# Examination of the Booster Short Straight Corrector Prototype Installation

October 13, 2008

We met to have a look at a prototype “short straight” assembly of the new Booster corrector and BPM as it would be installed on the new stand with the new valve and vacuum connections to the vacuum system. Several issues were raised that will require some amount of follow-up. This note is written to document the issues coming out of this examination of the assembly for future reference.

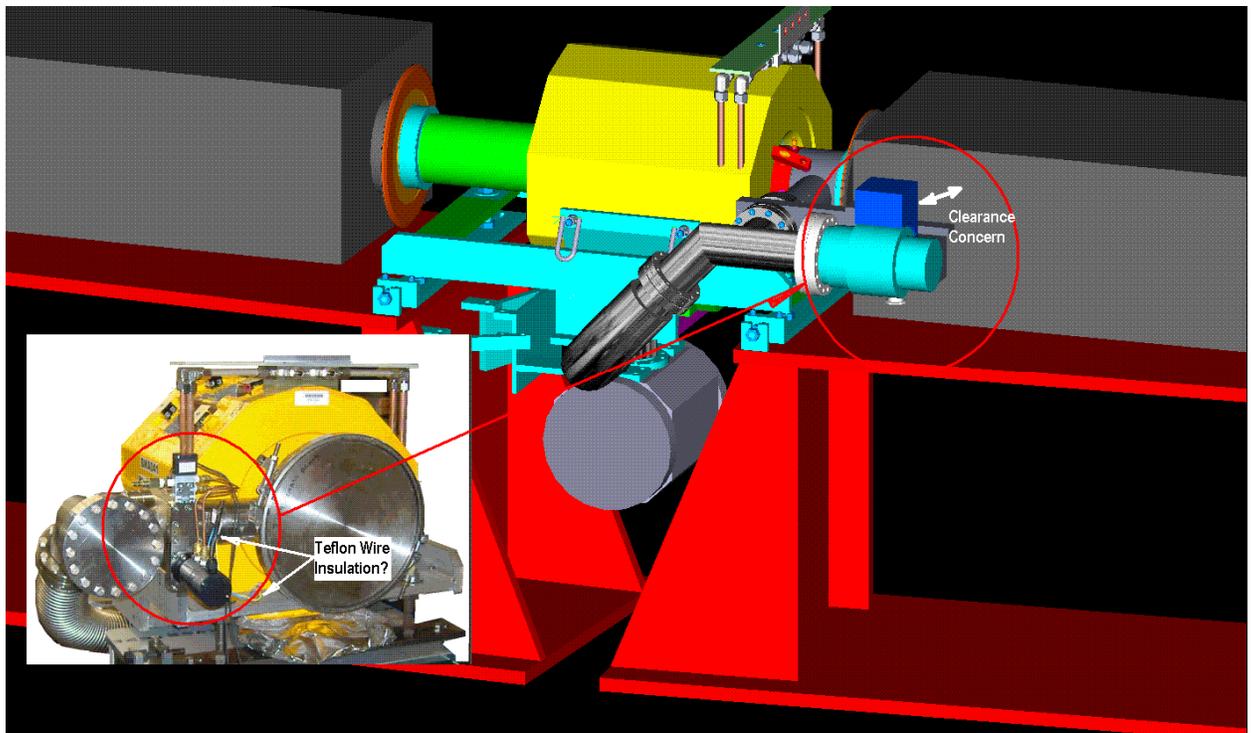
2. Ben Ogert took this opportunity to point that the current assembly layout will block a vacuum leak checking port such that the port adapter for his test equipment would no longer seat. Ben, Terry Anderson and Joel Misek discussed the options for alleviating the problem by providing another port or modifying a bracket that supports the turbo pump underneath the short straight assemblies.

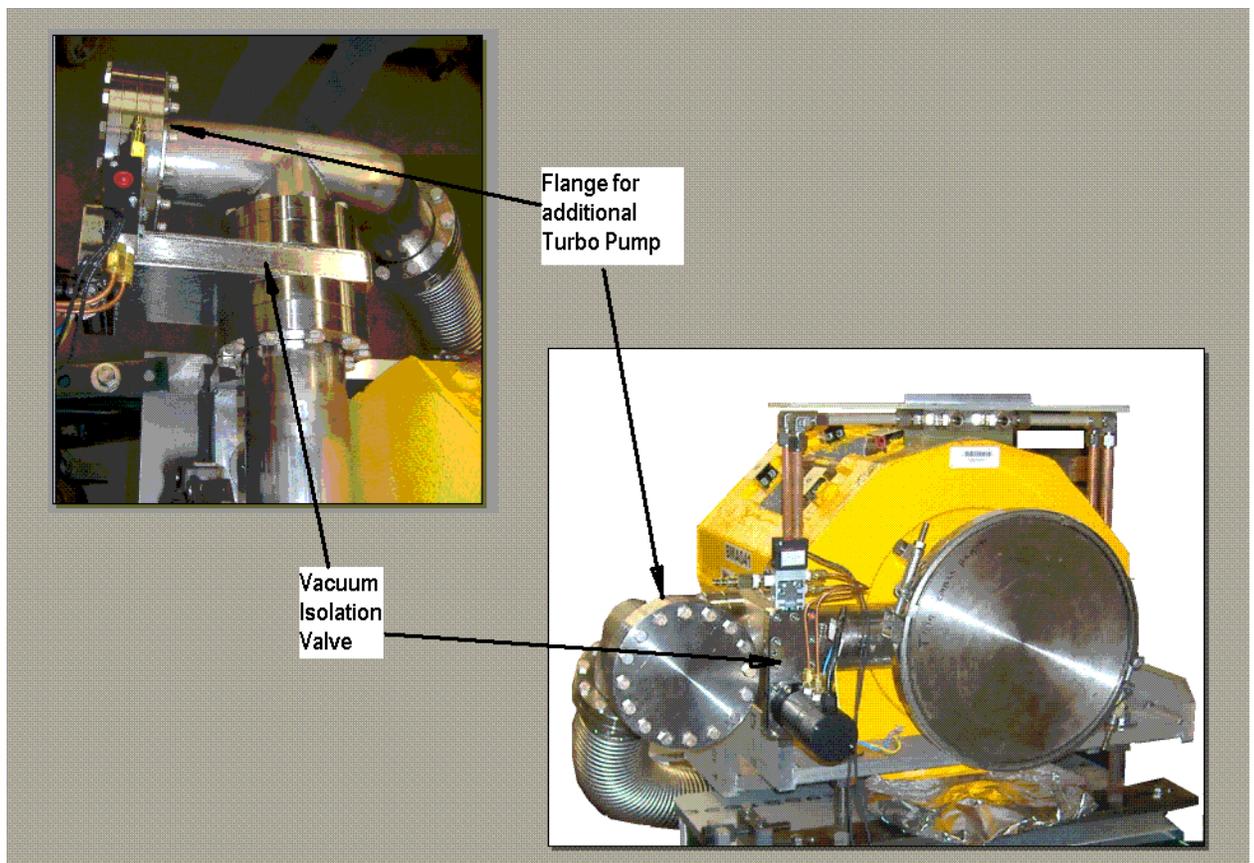
- Joel Misek pointed out that with the current assembly there is some movement of the beam pipe and BPM when the vacuum is made. The flexible vacuum hose contracts and pulls on the downstream end of the beam pipe assembly. Joel is considering both anchoring the downstream end to the assembly to the stand, and providing a G10 wedge/shim between the beam pipe and the corrector at the upstream end of the corrector.
